Serial No. 11-712  
LIC/CDS/R3  
Docket No. 50-305  
License No. DPR-43

**DOMINION ENERGY KEWAUNEE, INC.**  
**KEWAUNEE POWER STATION**  
**RESPONSE TO REQUEST FOR ADDITIONAL INFORMATION:**  
**LICENSE AMENDMENT REQUEST 244, PROPOSED REVISION TO**  
**RADIOLOGICAL ACCIDENT ANALYSIS AND CONTROL ROOM ENVELOPE**  
**HABITABILITY TECHNICAL SPECIFICATIONS (TAC NO. ME7110)**

**RESPONSE TO REQUEST FOR ADDITIONAL INFORMATION:  
LICENSE AMENDMENT REQUEST 244, PROPOSED REVISION TO  
RADIOLOGICAL ACCIDENT ANALYSIS AND CONTROL ROOM ENVELOPE  
HABITABILITY TECHNICAL SPECIFICATIONS**

CADD  
REV. NO. E-2003  
SCALE: NONE  
DWG. NO. E-2003  
REV. T

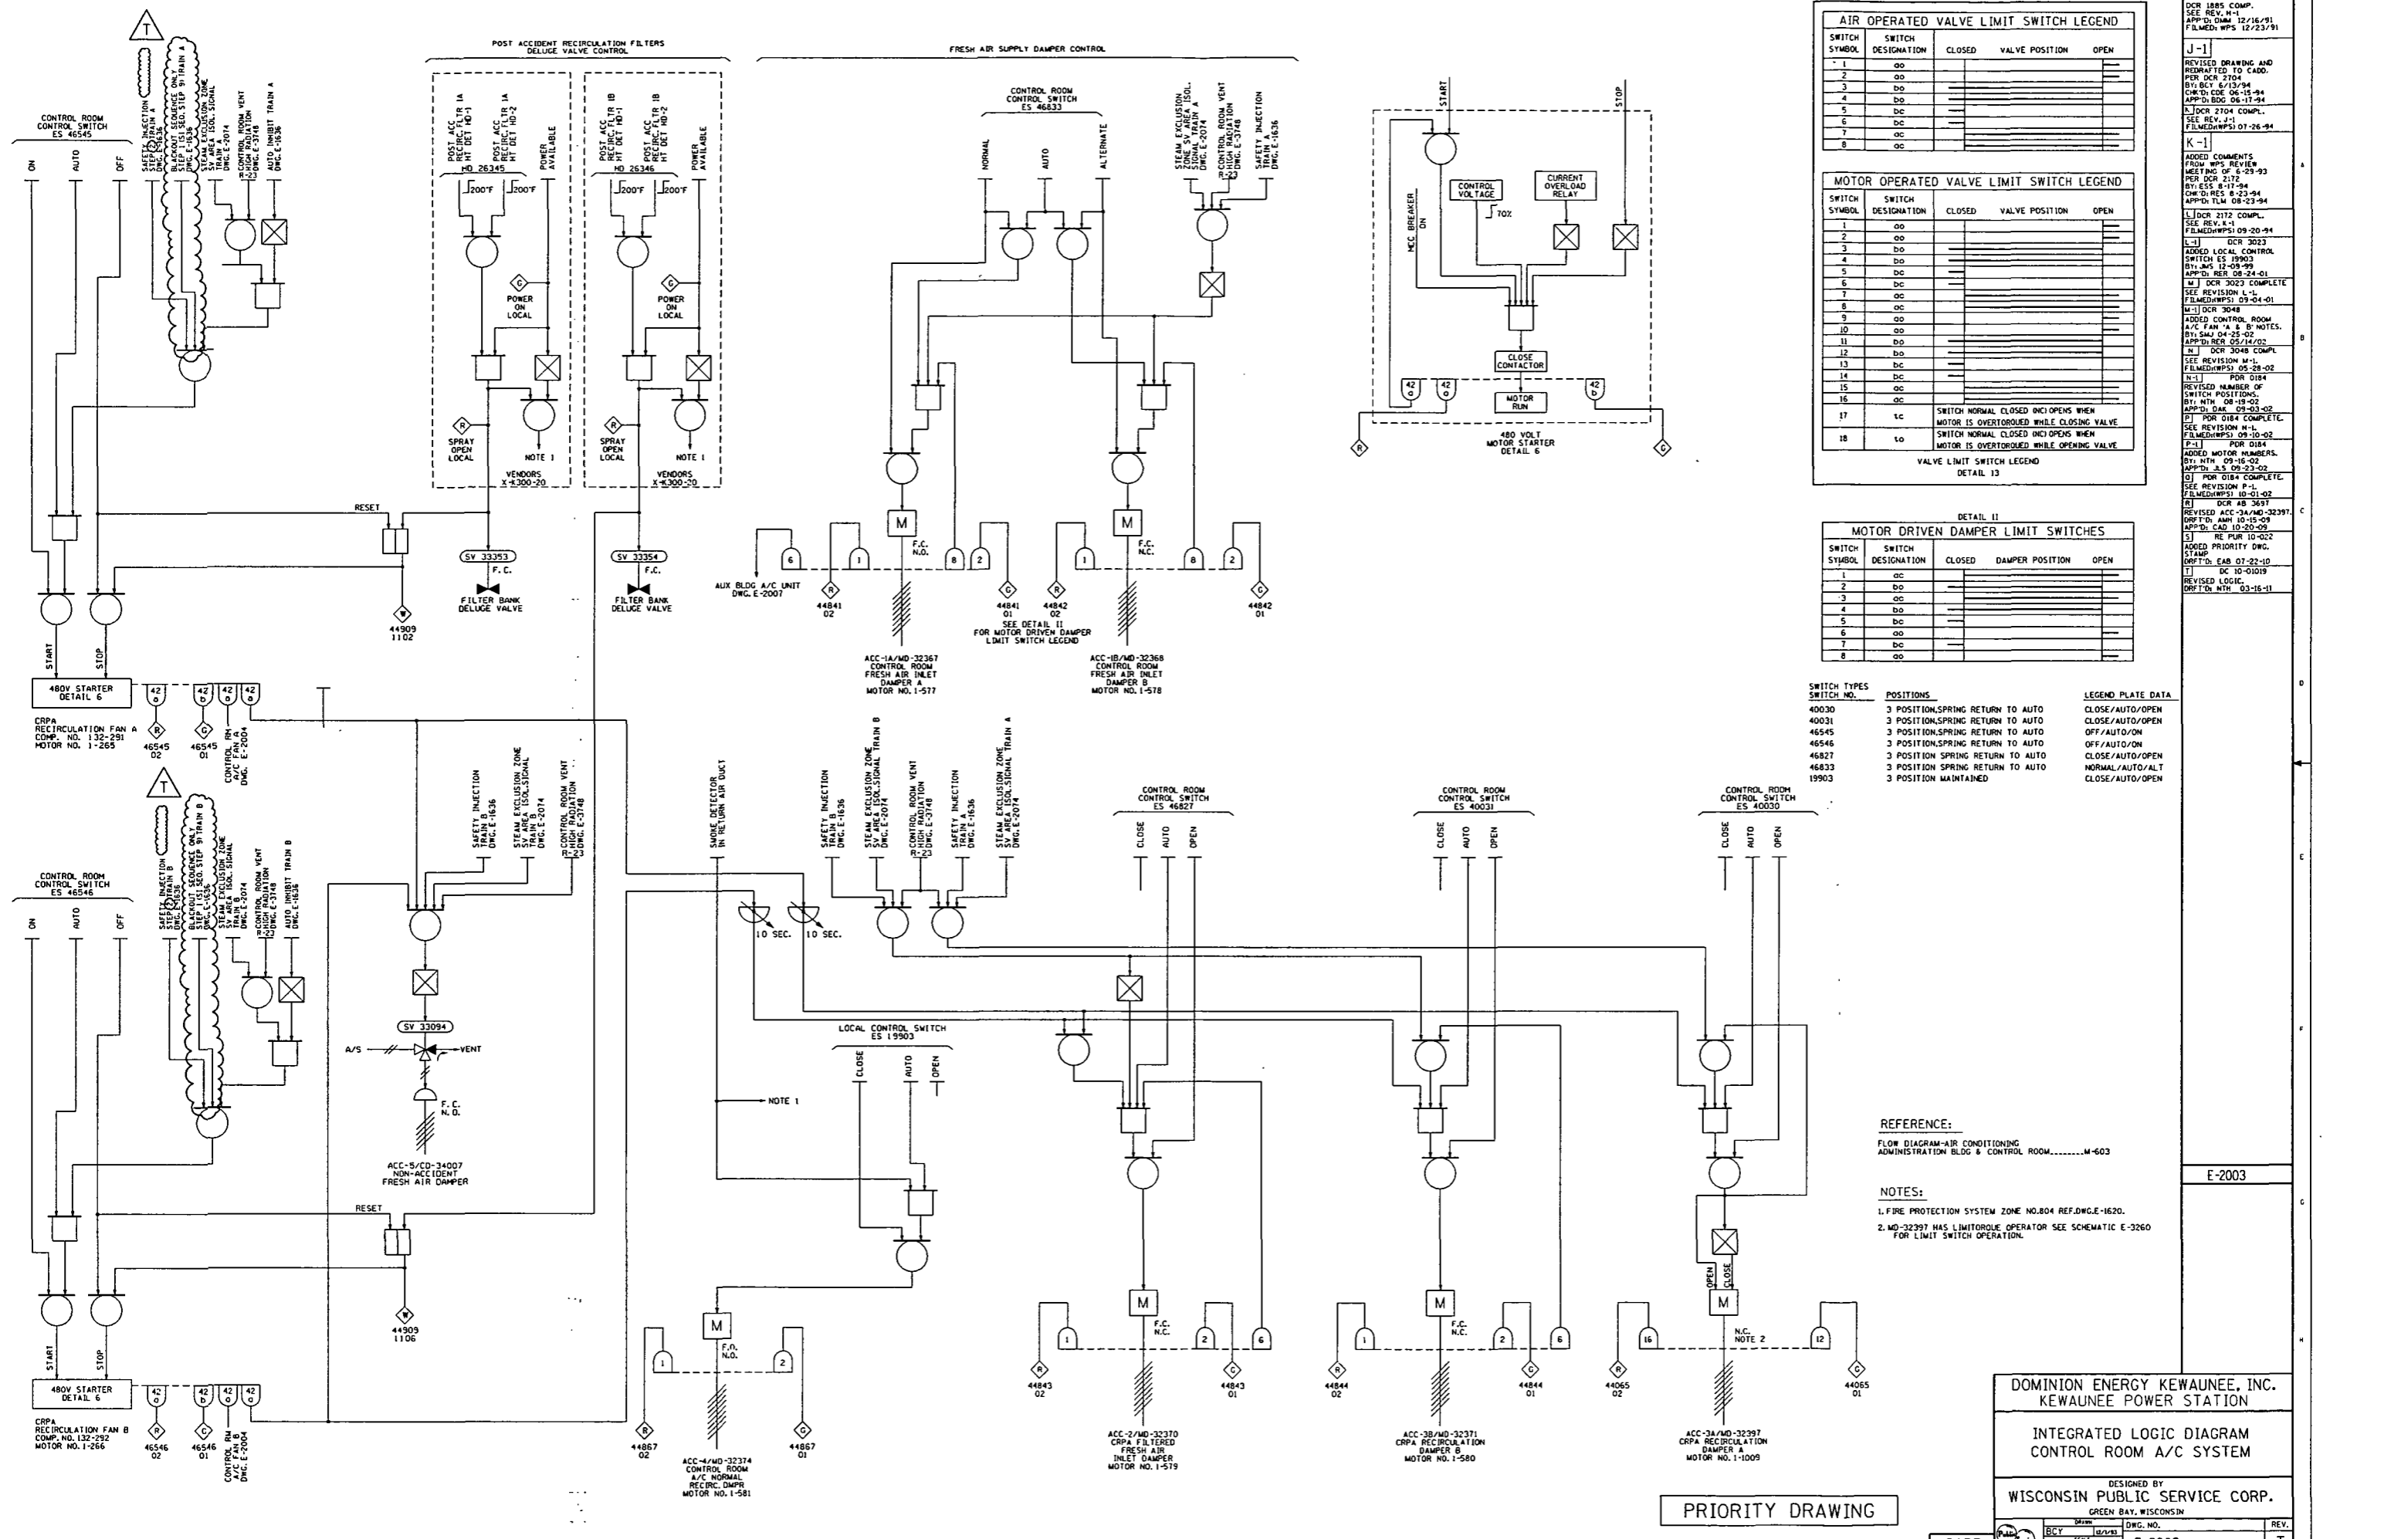
- a. Manual actuation is not part of the logic diagram for operation of the control room ventilation radiation monitor (FSAR Figure 9.6-6). Please clarify if this would be included in the logic diagram.*
- b. SI signal is not considered for all accident events (i.e., FHA, LRA, and GDT/VCT ruptures don't consider SI). In these cases manual action would be required. Please clarify if this would be included in the logic diagram.”*

*"LAR-244, Attachment 4, Section 2.7, 3.3.1, and 3.6.1, state that full control room isolation require action by the operator to close monitor dampers that are not included in the isolation logic (of the control room ventilation radiation monitor). This was not discussed in previous LARs or in FSARs. Please explain the following:*

- a. Where is this information described? Provide a logic diagram and a description for operation of all dampers required for the control room ventilation radiation system.*
- b. Are these monitor dampers closed by the SI signal? If not, what signal actuates them?"*

The revised FHA requires that the control room be isolated prior to moving recently irradiated fuel. This requirement has been proposed as a new TS 3.7.10 requirement. The revised FHA also requires that the CRPAR is started by manual operator action within 20 minutes of the release. This is accomplished by placing the control switch to ON to start the respective fan. The proposed manual action is simple, can be accomplished from the control room, and will be procedurally controlled. The manual start of CRPAR is shown on the CR ventilation logic diagram (see Logic Diagram E-2003 in Enclosure 1).

CR isolation and CRPAR start is shown on Logic Diagram E-2003 (see Enclosure 1).

- a. Actuation of the control room ventilation radiation monitor (R-23) is described in logic diagram E-2003, "Integrated Logic Diagram - Control Room A/C System." A copy of this logic diagram is included in Enclosure 1 of this letter. A description of the system response to an R-23 actuation is as follows:
  - Post-Accident Recirculation Fans A and B start.
  - A/C Fans A and B start if in **ON** or **AUTO**.
  - Motor Operated Dampers ACC-1A/MD-32367 and ACC-1B/MD-32368 close to isolate both control room fresh air intakes.
  - Solenoid Valve SV-33094 de-energizes and closes the Non-Accident Fresh Air Damper ACC-5/CD-34007.
  - Post-Accident Recirculation Dampers ACC-3A/MD-32397 and ACC-3B/MD-32371 open.
  - Normally closed Post-Accident Fresh Air Damper ACC-2/MD-32370 closes if open.

The following dampers must be closed to achieve full isolation of the control room boundary and are not isolated by an R-23 actuation signal. These dampers must be manually closed after an R-23 actuation signal unless the R-23 signal is accompanied by an SI signal.

- Close Recirculation Relief to Turbine Room Dampers ACC-20/CD-34061 and ACC-21/CD-34602.
- Close Kitchenette/Toilet Exhaust Dampers ACC-10/CD-34064 and ACC-11/CD-34063.
